Re: Request for Additional Information  
Docket No. 030-36971  
License No. 09-23920-01E

The following is a response to your request for additional information. Each response is enumerated per your questions.

**A. Information required for review of Sealed Source and Device amendment application.**

# NM1092C

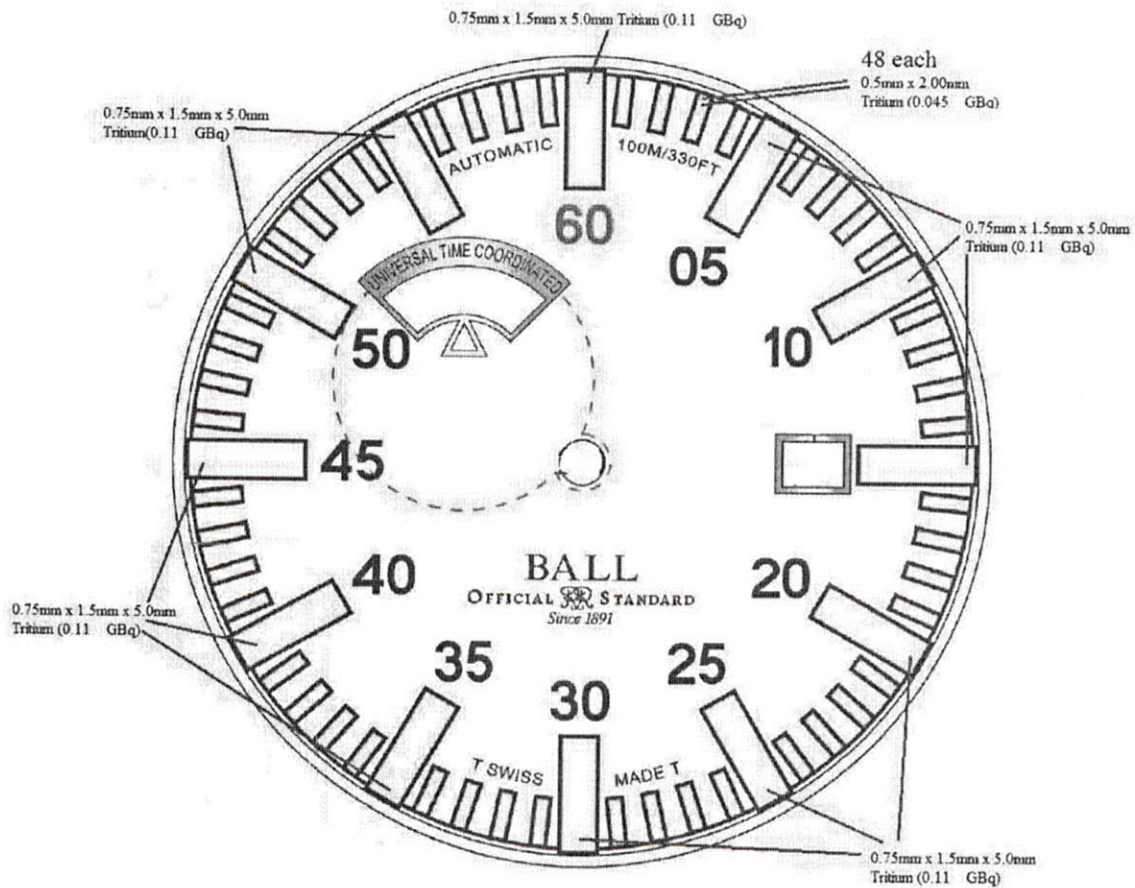
1. Model NM1092C will have 63 sources with a total of 102.3 mCi (3.79 GBq). Ball will mark timepieces between 100 mCi and 150 mCi with a "T150" on its face. To ensure 150 mCi timepieces can be distributed, this application for amendment was submitted.

2. The only changes will be the quantity and layout of the sources as depicted in Attachment A to this response.
3. The company name is "Hess Fine Arts, Inc. dba Ball Watch USA".

4. Attachments A, B, and C are included.
5. Hess Fine Art intends to add Model NM1092 to the Registration Certificate NR-1265-D-101-E. Please see Attachment A for the source layout and construction drawings of the timepiece.

48 each 0.5mm x 2.00mm	(0.045 GBq)	total = 2.16	GBq Dial 1-12h
11 each 0.75mm x 1.5mm x 5.0mm	(0.11 GBq)	total = 1.21	GBq Dial 1-11h
1 each 0.75mm x 1.5mm x 5.0mm	(0.11 GBq)	total = 0.11	GBq Dial 12h

1 each 0.65mm x 4.10mm	(0.134 GBq)	total = 0.134	GBq Hour hand
1 each 0.50mm x 6.50mm	(0.137 GBq)	total = 0.137	GBq Minute hand
1 each 0.50mm x 1.64mm	(0.035 GBq)	total = 0.035	GBq Second hand
